Washington Public Power Supply System
A JOINT OPERATING AGENCY

June 2, 1980
G01-80-171

Subject: WPPSS Nuclear Projects Nos. 1 & 4
Response to NRC Supplemental 10 CFR 50.54 Request

RESPONSE TO NPC REQUEST FOR ADDITIONAL INFORMATION
REGARDING WNP-1/4 SYSTEM SENSITIVITY

RCS RESPONSE TO REACTOR TRIP

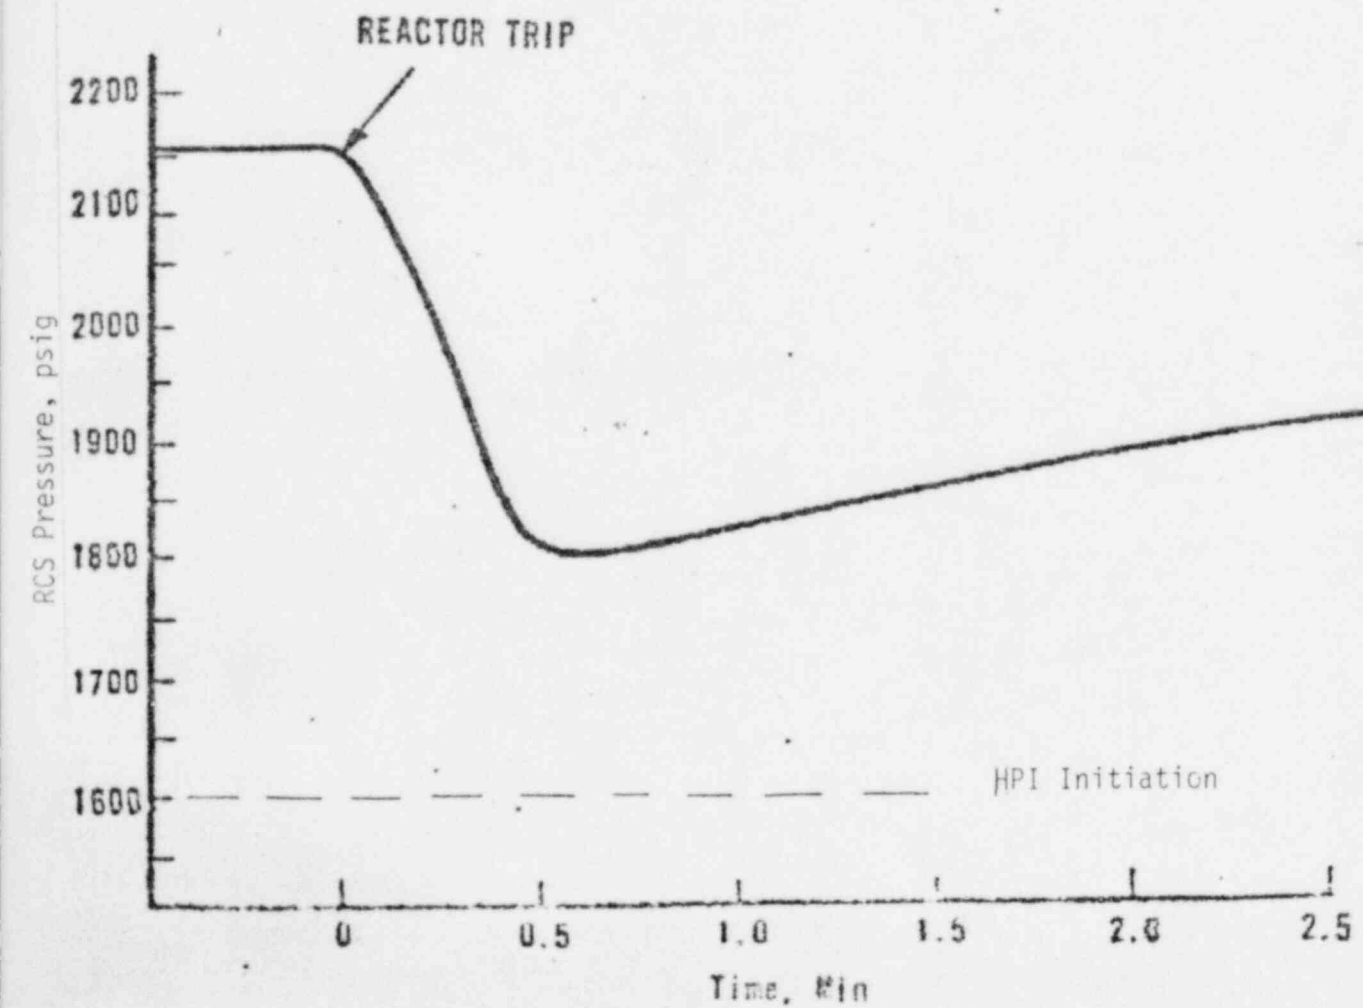
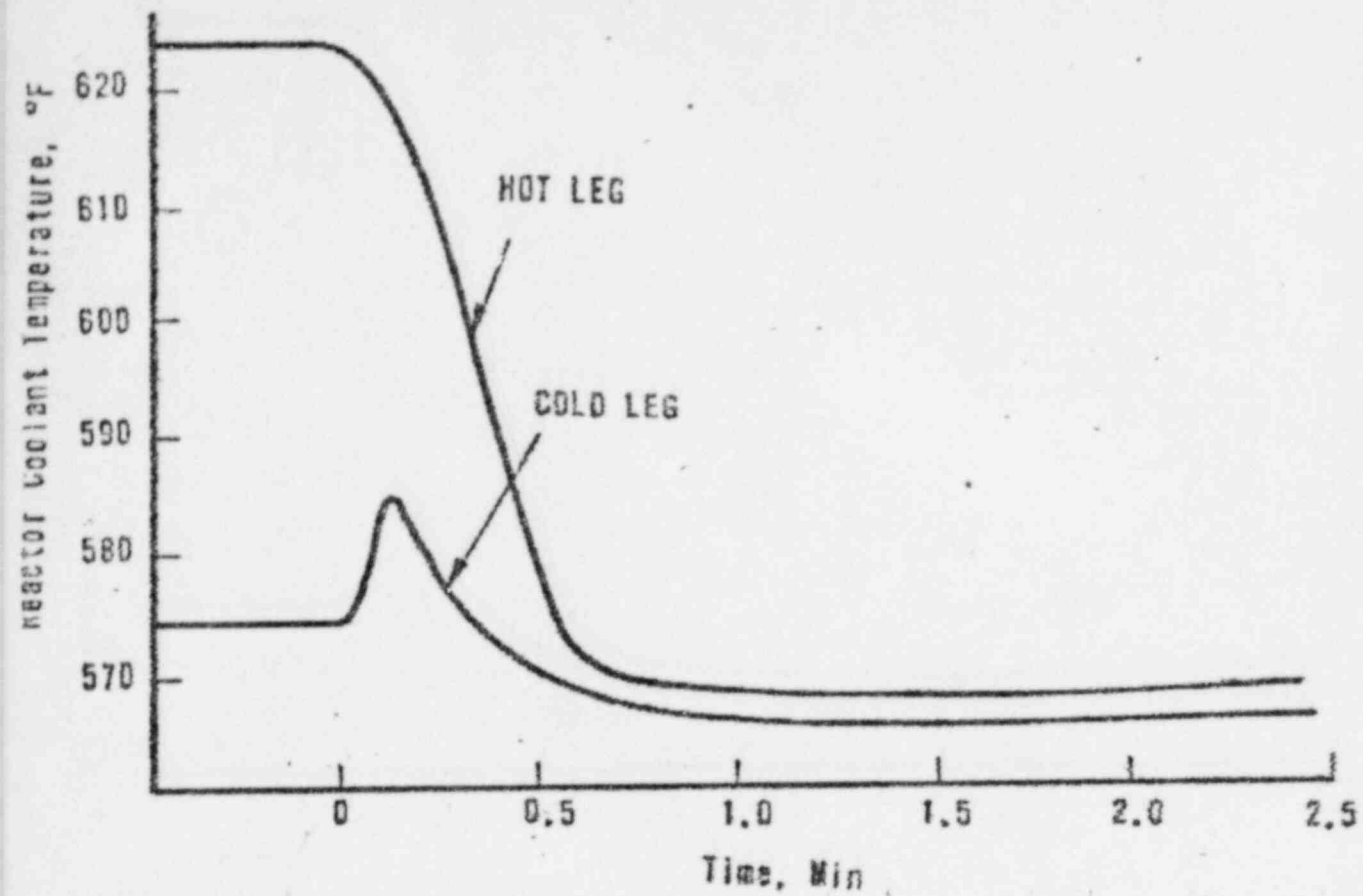
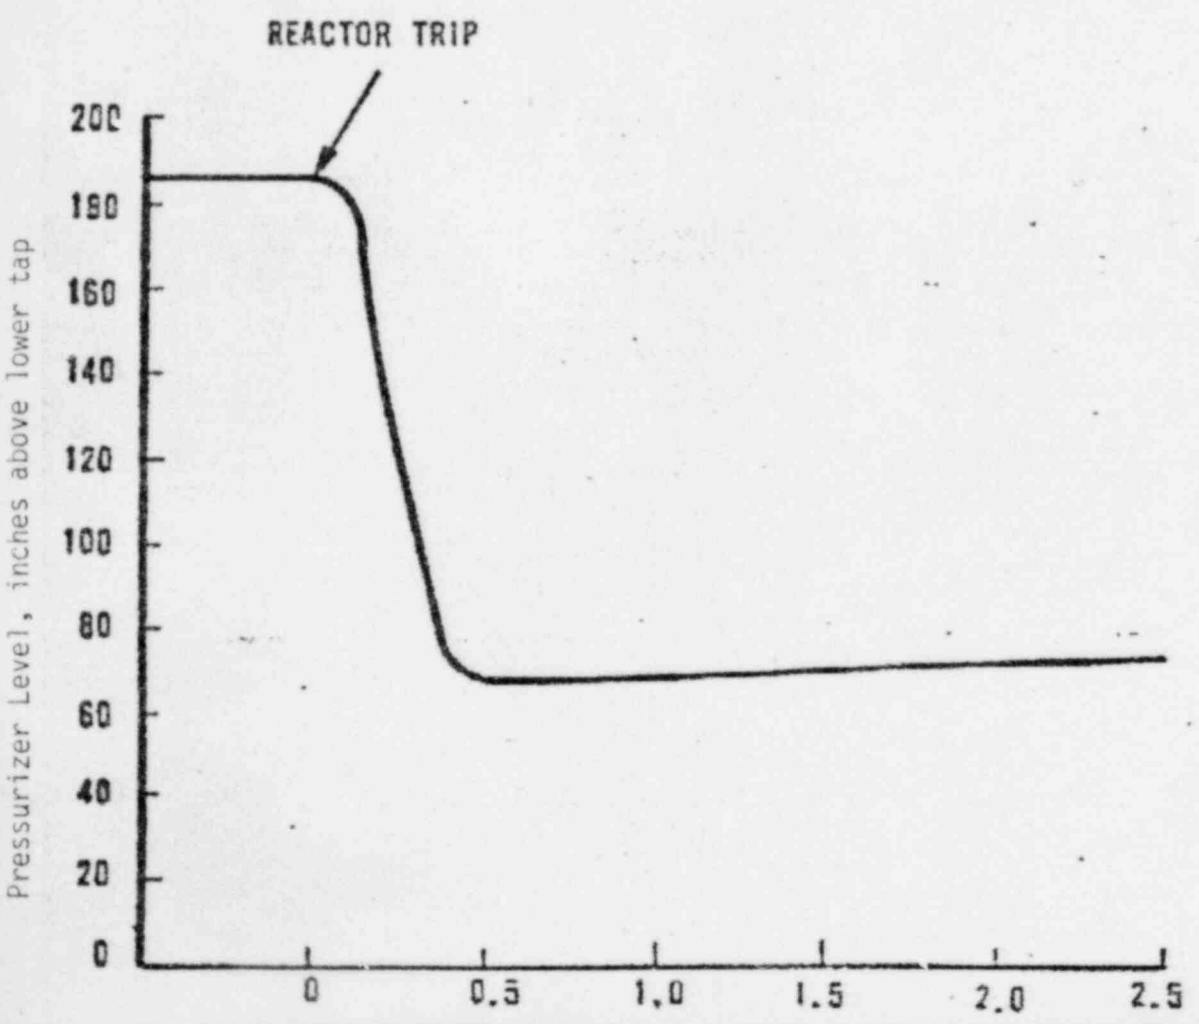
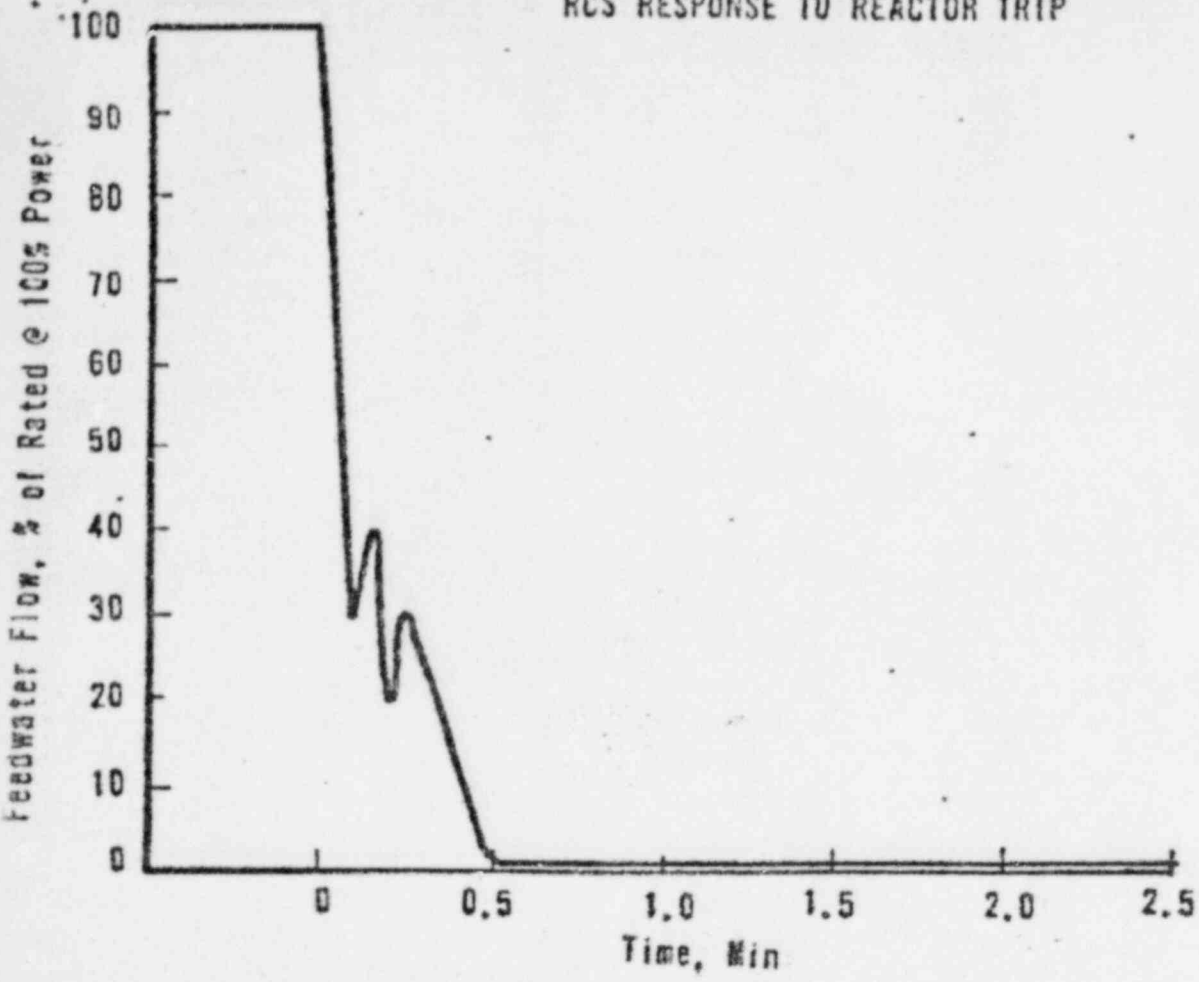
Experience at operating B&W plants have indicated that the dynamics associated with main feedwater termination and steam generator pressure control following a reactor trip can lead to overcooling of the primary system. Discuss your criteria and the adequacy of your existing and proposed design features and changes to preclude this overcooling situation.

Figure 1 illustrates reactor coolant temperature, pressure, feedwater flow and pressurizer level following a reactor trip with proper feedwater flow and main steam pressure control. The rapid decrease in reactor power causes reactor coolant temperature to decrease (due to large heat transfer surface area in each steam generator); the resultant reactor coolant contraction causes a decrease in reactor coolant liquid volume and pressure. The reactor coolant cold leg temperature reaches an equilibrium value nearly equal to the saturation temperature of the secondary side steam pressure (567F at 1200 psia), and the reactor coolant pressure will eventually be restored to the normal operating pressure of 2210 psia.
